**STRATEGIC HOUSING DEVELOPMENT PLANNING
APPLICATION
RESPONSE TO AN BORD
PLEANALA OPINION**

**FOR LANDS AT HOLY CROSS COLLEGE, CLONLIFFE ROAD, DUBLIN 3
AND DRUMCONDRA ROAD LOWER, DRUMCONDRA, DUBLIN 9**

**CWTC Multi Family ICAV acting on behalf of its
sub-fund DBTR DR1 Fund**

July 2021

Diagram - Massing & Height Strategy - Block D2 Current Proposal

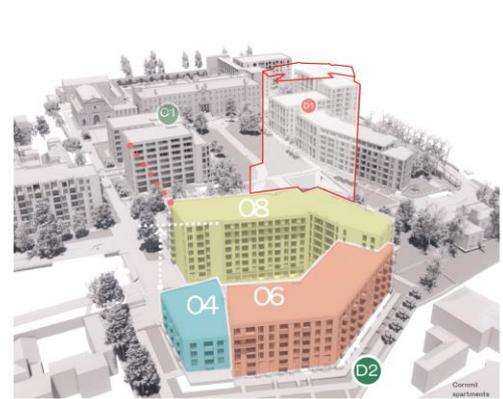
Further consideration and/or justification of the documents as they relate to impact of the proposed development on the residential amenity of the existing neighbouring dwellings, having regard, inter alia, the location and design of Block D2 and the potential for a negative impact on the visual and residential amenity of existing occupants to the east. Additional Computer-Generated Images (CGIs) and visualisation/cross section drawings showing the proposed development in the context of the existing residential properties surrounding the site may further elaborate on the visual impact on these properties. This further consideration may require the submission of updated sunlight and daylight analysis detailing compliance with the recommended standards.

The massing of the blocks has evolved further since the ABP Opinion to address any issues in respect of potential impact on the neighbouring Cornmill apartments.

The building line on the eastern façade of Block D2 has been set back further from the site boundary and subsequently the separation from the adjacent Cornmill Apartments has increased. In terms of height, as the scheme now reduces from 7 storeys at its highest along this edge to 6 storeys to more appropriately respond to the heights in the adjacent buildings.

This is considered further in the Landscape Design Report prepared by NMP as well as landscape open space plan L1-301 (also above) for further detail of overall strategy.

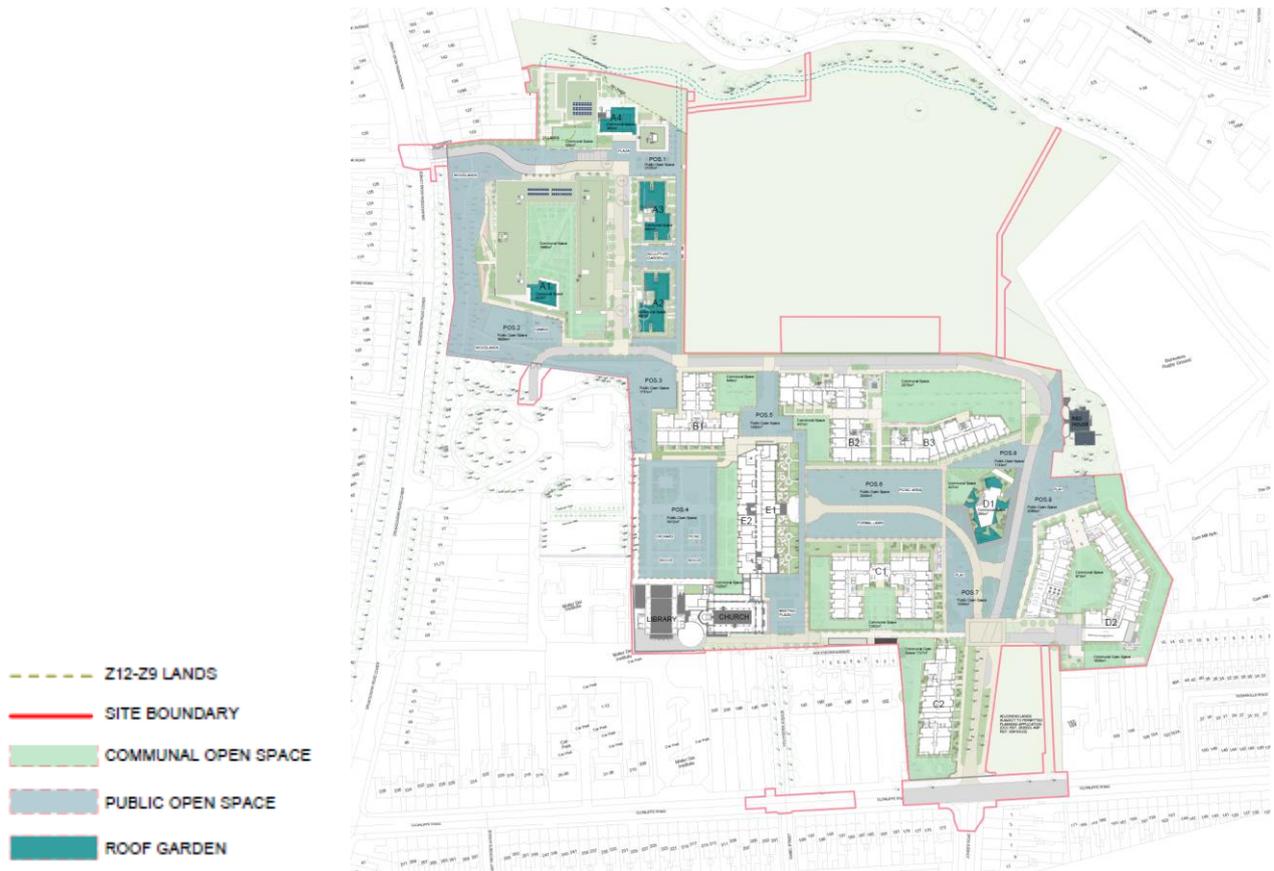
A quantitative and qualitative assessment which provides a breakdown of the public open space. The assessment shall detail the functionality of the public space and shall disregard any areas required for circulation space such as footpaths between buildings etc.

The public open space is a key feature of the proposed scheme. The proposed development meets this requirement through the landscape strategy which responds to the rich green character of the surrounding context along the river Tolka, the tree lined Drumcondra Road. The development plots have been defined by the site heritage and existing landscaping features. The intention is to 'gently' site the buildings within the landscape in order to create a sustainable, yet legible urban grain.

Public open space is provided at 25% of the development area which amounts to c.2 ha or 20,410 sq.m in excess of the Development Plan requirements of 20%.
